Subject: Amendment Request - Village of Waunakee, Resolution DC-2017-19

#### Resolution CARPC No. 2017-19

# Staff Analysis of a Proposed Amendment to the Dane County Water Quality Plan, Revising the Environmental Corridors of the Waunakee Urban Service Area in the Village of Waunakee

Map 5 –Conceptual Restoration Plan

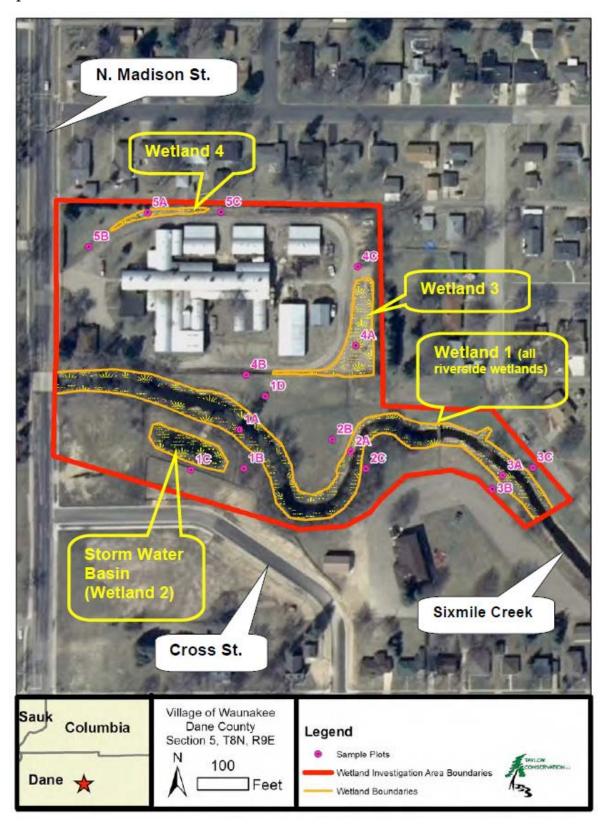
The purpose of a vegetated buffer is to provide water quality and wildlife protection functions. The proposed minimum vegetated buffer width of 20 feet is insufficient to provide effective sediment and phosphorus removal. But the proposed stormwater management facilities will provide this stormwater management function. Therefore the proposed buffer width reduction should not have a negative effect on water quality. The proposed buffer width will provide little to no wildlife protection benefits, as is the case with the standard 75 foot buffer. The proposed buffer vegetation, however, will provide a significantly better habitat compared to the current condition of poor quality or invasive trees and low mowed turf grass.

- 1. Consider expanding the riparian buffer restoration plan for the site to include the south side of Six Mile Creek.
- 2. Consider using permeable pavement for the shared use path, access drive, and/or parking spaces, where appropriate based on groundwater depths.
- 3. Encourage the responsible use of deicers at the site as part of the <u>WI Salt Wise Partnership</u>.

- 3. Develop and implement a riparian buffer restoration and vegetation management plan for the site.
- 4. The restored riparian buffer, wetlands, and stormwater management facilities shall be designated as environmental corridors.
- 5. Stormwater runoff from all impervious surfaces shall be directed to one of the proposed stormwater management facilities prior to discharging to the wetlands or Six Mile Creek, to the extent feasible.

Map 6 –Conceptual Stormwater and Erosion Control Plan ASSOCIATES, WAUNAKEE LIBRARY త SNYDER 116.0144.30

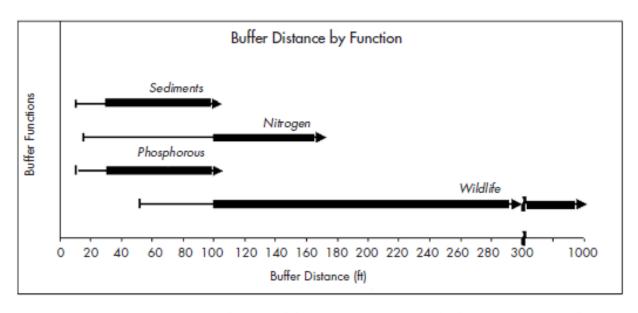
The stormwater management plan will be required to meet or exceed total suspended solid reduction, peak runoff rates, oil and grease control, and infiltration/stay-on requirements in the Village of Waunakee and Dane County ordinances. This will provide better water quality compared to the current industrial site that was constructed prior to any stormwater management requirements.

- 1. Obtain a wetland general permit from the Wisconsin Department of Natural Resources and, if necessary, the U.S. Army Corps of Engineers for the proposed 7,320 square feet of wetland fill.
- 2. Submit a detailed stormwater management plan for CARPC staff review and approval (in conjunction with DCL&WCD staff) for the amendment area. The stormwater management plans shall meet the requirements of the Village of Waunakee (Chapter 109) and Dane County (Chapter 14) stormwater ordinances.
